FORMAL ADA/PROWAG CIVIL RIGHTS GRIEVANCE

City of Bloomington, Indiana

717 S. Henderson Street — Removal of Accessible Pedestrian Route During Redevelopment; Failure of ADA/PROWAG Review in Planning, Permitting, Construction, and Complaint-Intake Process

Re: ADA / PROWAG Non-Compliance — Removal of Accessible Pedestrian Route, 717 S. Henderson Street; Failure to Provide Accessible Alternate Route During Construction; Failure of ADA/PROWAG Review and Complaint-Routing Process

Fig. 2: Google Street View imagery dated May 2019, 717 S. Henderson on right.

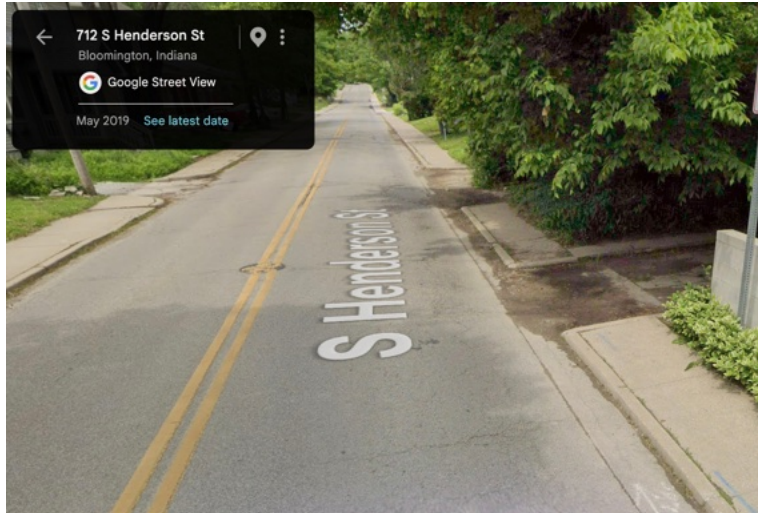
The complainant's understanding of the history of this frontage, based on available Google Street View imagery and direct observation, is as follows. In approximately 2017, and as late as May 2019, the sidewalk condition in this area was discontinuous and did not provide a continuous accessible pedestrian route (Fig. 2). At some point after 2019, and before the 717 S. Henderson redevelopment began, the City or a prior property owner improved the frontage to provide a continuous, direct, paved concrete pedestrian route. Google Maps Street View imagery dated April 2026 — captured after redevelopment had begun but before the sidewalk was relocated — shows that a continuous concrete sidewalk ran in a straight line along this frontage and that the alley crossing was paved at that time (Fig. 3).

This sequence matters because it establishes that the City had already moved this location toward accessibility compliance by the time the 717 S. Henderson redevelopment began. The redevelopment did not occur at a location where no accessible route had ever existed; it occurred at a location where a continuous accessible route already existed and was then interrupted and replaced by a substantially worse condition.

Fig. 5: Photograph of the alley-cut condition on the west side of S. Henderson Street, at the continuation of the same alley right-of-way shown in Fig. 1 (complainant's photograph).

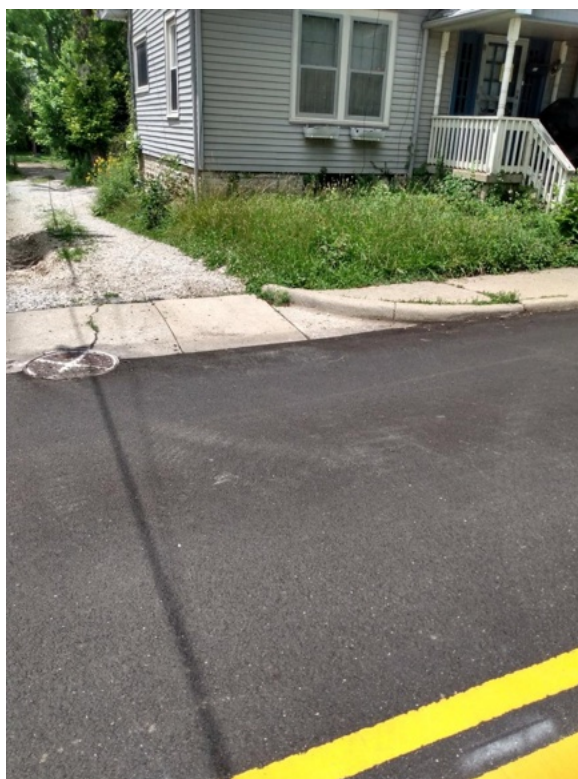
To the extent the City takes the position that pedestrians could simply use the sidewalk on the opposite (west) side of S. Henderson Street, that position does not withstand examination. The west-side sidewalk, at the point where it adjoins the continuation of the same alley right-of-way, itself contains an impassable or noncompliant alley-cut condition (Fig. 5). A pedestrian using a wheelchair or other mobility device who is blocked at 717 S. Henderson cannot simply cross the street to a fully accessible alternate route; the opposite frontage presents a comparable barrier at the same alley crossing.

As documented in Section 2.5 and Fig. 5, the west-side sidewalk presents a comparable barrier at the same alley crossing and is not a meaningful accessible alternative.
